ACCESSION# NBR: 8110190506 DOC. DATE: 81/10/12 NOTARIZED: NO DOCKET# 05000397
 FACIL: 50-397 WPPSS Nuclear Project, Unit 2, Washington Public Power
 AUTH. NAME: BOUCHEY, G. D. AUTHOR AFFILIATION: Washington Public Power Supply System
 RECIP. NAME: SCHWENCER, A. RECIPIENT AFFILIATION: Licensing Branch 2

SUBJECT: Forwards responses to Geosciences Branch 810504 second round questions re neotectonic models or alternative models of Columbia Plateau. Final draft of FSAR Sections 2.5.1 & 2.5.2 will be submitted as Amend 18 on or about 811020.

Subject: SUPPLY SYSTEM NUCLEAR PROJECT NO. 2
RESPONSES, GEOSCIENCES BRANCH TO ROUND TWO
QUESTIONS AND FINAL DRAFT OF FSAR SECTIONS 2.5.1 and 2.5.2

<p>LOCATION MAP OF COLUMBIA PLATEAU SHOWING STRONG MOTION INSTRUMENT SITES</p>	<p>Figure 361.6-1</p>
--	---------------------------

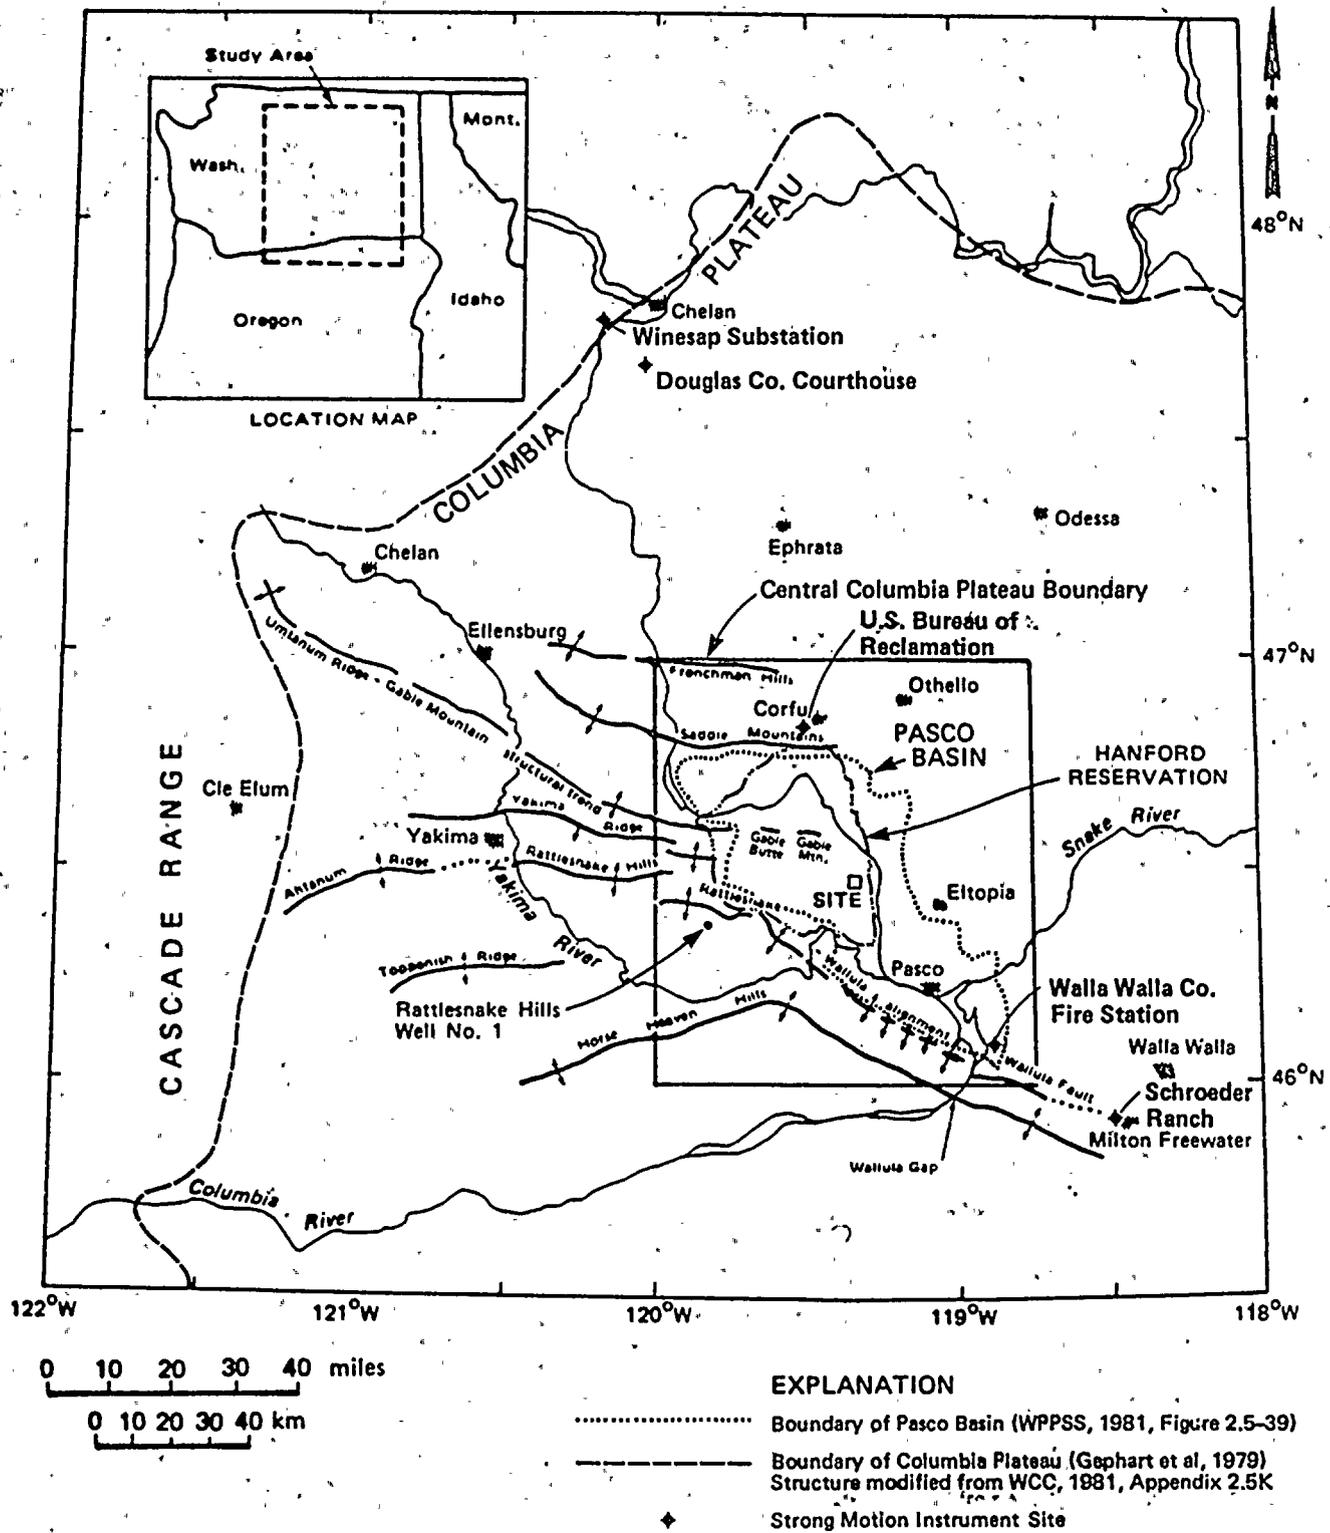
Provide the location and dates of operation of the strong motion instruments mentioned in your January 27, 1981, work plan.

The location and dates of installation of the strong motion instruments mentioned in the Supply System's January 27, 1981, work plan are as follows:

These locations are shown on Figure 361.6-1.
